APPLICATION NO.	FILING DATE	FIRST NAMED INVENTOR	ATTORNEY DOCKET NO.	CONFIRMATION NO.
10/622,960	07/18/2003	Ralph D. Geater	GEAT100USA	4002
24339	7590 11/29/2004		EXAMINER	
JOEL D. SKINNER, JR. SKINNER AND ASSOCIATES 212 COMMERCIAL ST.			SZUMNY, JONATHON A	
			ART UNIT	, PAPER NUMBER
HUDSON, W	/I 54016		3632	
			DATE MAILED: 11/29/2004

This is the second office action for application number 10/622,960, Fastener Technology, filed on July 18, 2003.

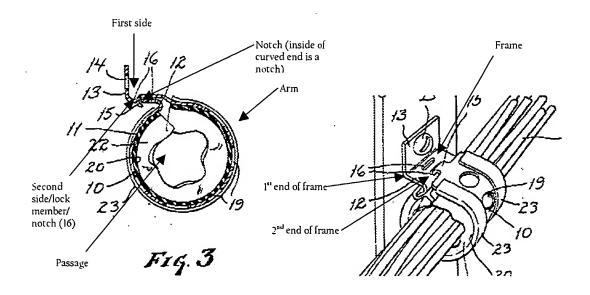
Claims 1, 2, 6-8, 11-15, 19 and 20 are rejected under 35 U.S.C. 102(b) as being anticipated by U.S. Patent number 2,340,713 to Tinnerman.

Tinnerman '713 discloses a unitary device (above) comprising a rectilinear frame (above). a planar leg (13) communicatively connected to the frame at the first end and on a first side of the frame, and a first end of a curvilinear arm (above) connected to the frame and defining a cylindrical passage (above) with open ends, wherein the frame has first and second ends (above) and a predetermined length, wherein the leg has a predetermined configuration with a predetermined area and depends from the first end of the frame at a right angle thereto, wherein the device includes connecting means/screw (B), wherein an aperture (14) is disposed at a predetermined location in the leg at a central area thereof, wherein the device could inherently attach to a wall stud, wherein the arm pivotally depends from the second end and second side of the frame, wherein the arm is flexible (column 1, line 49, "spring"), wherein the device can be/is inherently separated a predetermined distance from an external base object., wherein a lock member (above) is connected to the frame on a second side (above) thereof, wherein the second end of the arm has a locking end which releasably mates with the lock member to open and close the passage, wherein the lock member and locking end have complementary mating notches (above), wherein the cylindrical passage is oriented parallel with the plane of the leg, wherein the passage could inherently be adapted to be disposed any number of various distances away from a stud, including approximately 1 5/8 inches.
